Submit 1 Copy To Appropriate District State of New Mexico	Form C-103
Office Energy Minamla and Natural Da	
District I – (575) 393-6161 Energy, Millerais and Natural Re 1625 N. French Dr., Hobbs, NM 88240	WELL API NO.
District II – (575) 748-1283 811 S. First St., Artesia, NM 88210 OIL CONSERVATION DIV	ISION 30-041-20698
<u>District III</u> – (505) 334-6178 1220 South St. Francis D	5. Indicate Type of Lease
1000 Rio Brazos Rd., Aztec, NM 87410 District IV – (505) 476-3460 Santa Fe, NM 87505	6. State Oil & Gas Lease No.
1220 S. St. Francis Dr., Santa Fe, NM	o. State on & Gas Eduse No.
87505 SUNDRY NOTICES AND REPORTS ON WELLS	7. Lease Name or Unit Agreement Name
(DO NOT USE THIS FORM FOR PROPOSALS TO DRILL OR TO DEEPEN OR PLUG BAC	
DIFFERENT RESERVOIR. USE "APPLICATION FOR PERMIT" (FORM C-101) FOR SUCI PROPOSALS.)	Н

Received by WCD.S/30/2021 1:26:50 PM U.S. Department of the Interior		Sundry Print Report 03/25/2021
BUREAU OF LAND MANAGEMENT		
Well Name: FARRELL FEDERAL	Well Location: T7S / R33E / SEC 28 / SWSW /	County or Parish/State: ROOSEVELT / NM
Well Number: 23	Type of Well: OIL WELL	Allottee or Tribe Name:
Lease Number: NMNM83197	Unit or CA Name:	Unit or CA Number:
US Well Num

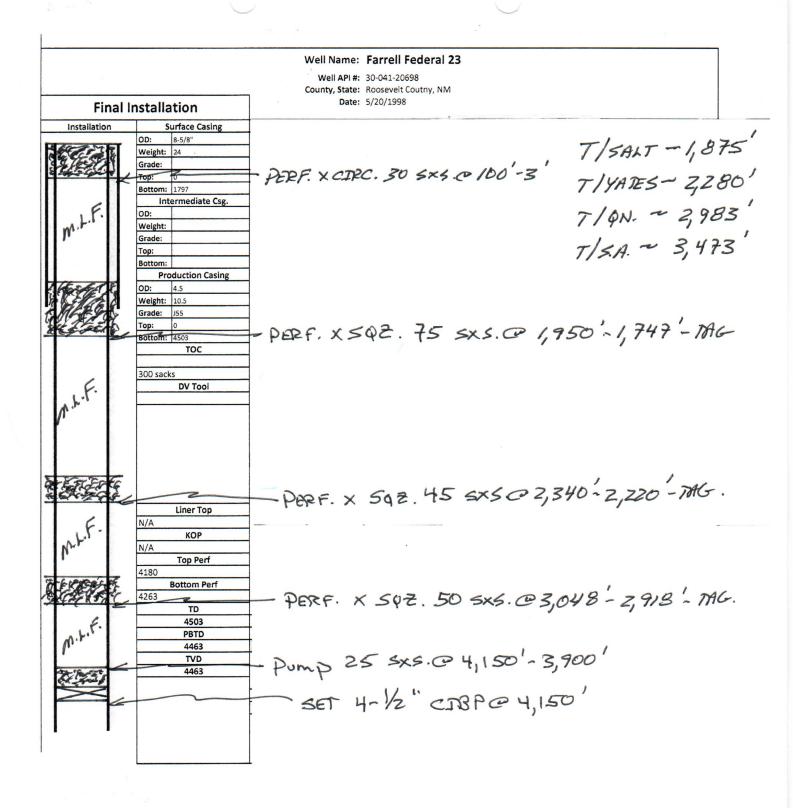
- 1. Operator shall place CIBP at 4,130' (50'-100' above top most perf) and place 25 sx of Class C cement on top as proposed. <u>WOC and TAG.</u>
- 2. Operator shall perf and squeeze at 3,048' as proposed. Operator shall place a balanced Class C cement plug from 3,048'-2,918' as proposed. <u>WOC and TAG</u>.

- 3. Operator shall perf and squeeze at 2,340'. Operator shall place a balanced Class C cement plug from 2,340'-2,185' to seal the Yates Formation and the bottom of the Salt. <u>WOC and TAG.</u>

- 4. Operator shall perf and squeeze at 2,048'. Operator shall place a balanced Class C cement plug from 2,048'-1,825' to seal the top of the Salt. <u>WOC and TAG</u>.

- 5. Operator shall perf and squeeze at 1,847'. Operator shall place a balanced Class C cement plug from 1,847'-1,747' to seal the 8-5/8'' casing shoe. <u>WOC and TAG</u>.

- 6. Operator shall perf and squeeze at 200'as proposed. Operator shall place a balanced Class C cement plug from 200' to surface.
- 7. See Attached for general plugging stipulations.

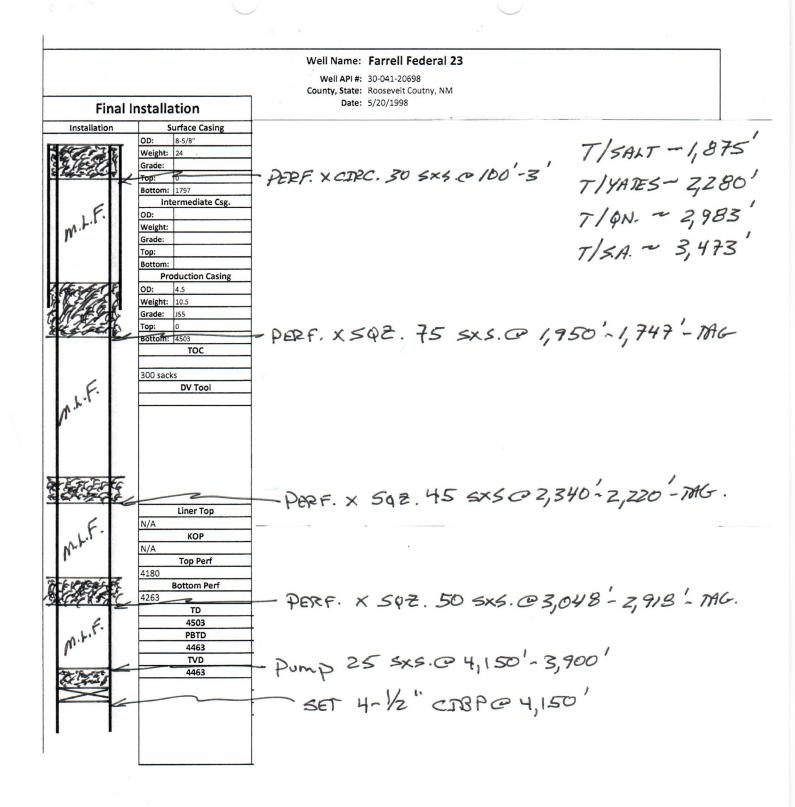
- 1. Operator shall place CIBP at 4,130' (50'-100' above top most perf) and place 25 sx of Class C cement on top as proposed. <u>WOC and TAG.</u>
- 2. Operator shall perf and squeeze at 3,048' as proposed. Operator shall place a balanced Class C cement plug from 3,048'-2,918' as proposed. <u>WOC and TAG</u>.

- 3. Operator shall perf and squeeze at 2,340'. Operator shall place a balanced Class C cement plug from 2,340'-2,185' to seal the Yates Formation and the bottom of the Salt. <u>WOC and TAG.</u>

- 4. Operator shall perf and squeeze at 2,048'. Operator shall place a balanced Class C cement plug from 2,048'-1,825' to seal the top of the Salt. <u>WOC and TAG</u>.

- 5. Operator shall perf and squeeze at 1,847'. Operator shall place a balanced Class C cement plug from 1,847'-1,747' to seal the 8-5/8'' casing shoe. <u>WOC and TAG</u>.

- 6. Operator shall perf and squeeze at 200'as proposed. Operator shall place a balanced Class C cement plug from 200' to surface.
- 7. See Attached for general plugging stipulations.
